ANTI-SIDE-TONE INDUCTION COIL TELEPHONE— AUTOMATIC AREAS.

N. 332. 9-4-35
5 PANELS-1

N 332
2 PANELS-1
16-12-36

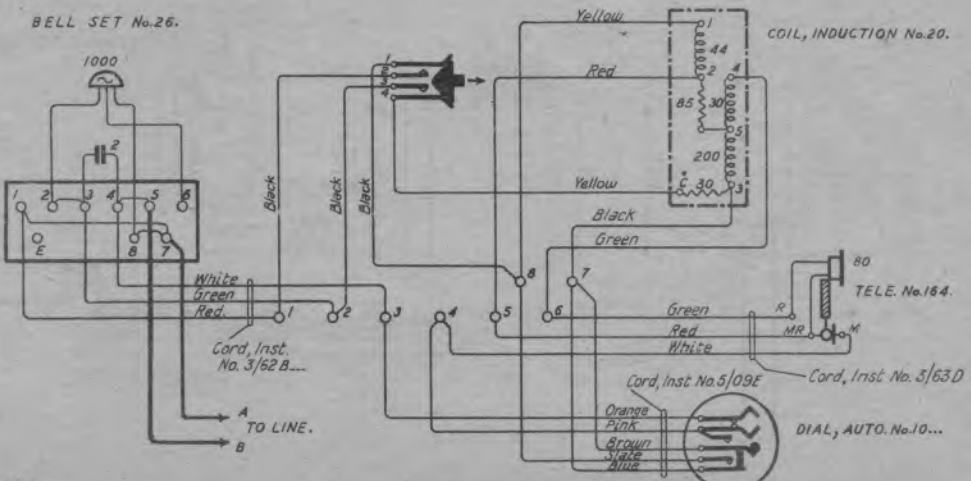
TELE. No. 1/232... (Wk. 2) AND
PANELS 4 & 5 ADDED.
Sheet 2 rechecked.
Sheet 2 rechecked.
Suppression Note Added & Dial No. 411-688 Directed
(Sul) Set. No. 26. Redrawn

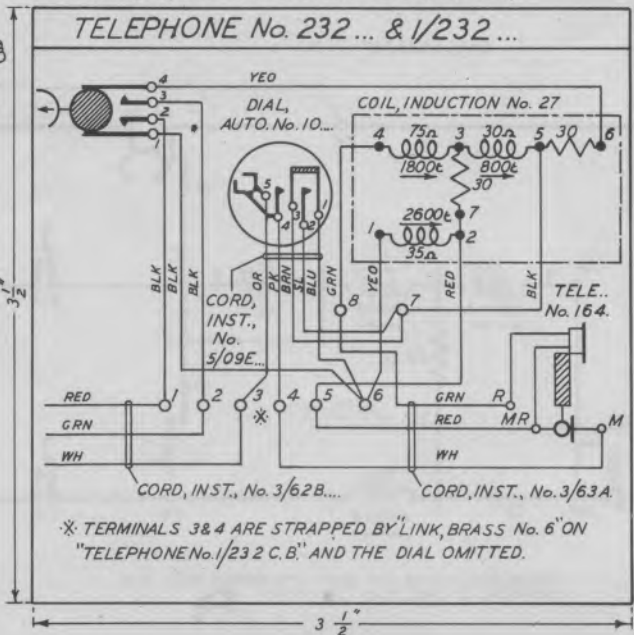
PANELS 1, 2 & 3 CANCELLED, PANELS 4 & 5 MADE
1 & 2. NOTES 3 & 4 ADDED.
TELE. No. 1/232... (Wk. 2) & PANELS 4 & 5 ADDED.
15-4-51 AC & 15-4-51 AC AMENDED
SEE SUPERSEDED TRACING.

- NOTES:-
1. ON TELES. No. 1/232... TO EARLIER PATTERN THE CONNEXIONS TO TERMINALS 6 & 8 ARE REVERSED.
 2. THE LABEL DGM. FOR TELE. No. 1/232... TO BE TO DIMENSIONS GIVEN.
 3. IN EARLIER ISSUES THE CONNEXIONS TO DIAL TERMINALS 1 & 2 WERE REVERSED.
 4. EARLIER ISSUES WERE FITTED WITH COIL INDUCTION No. 20 OR 24.
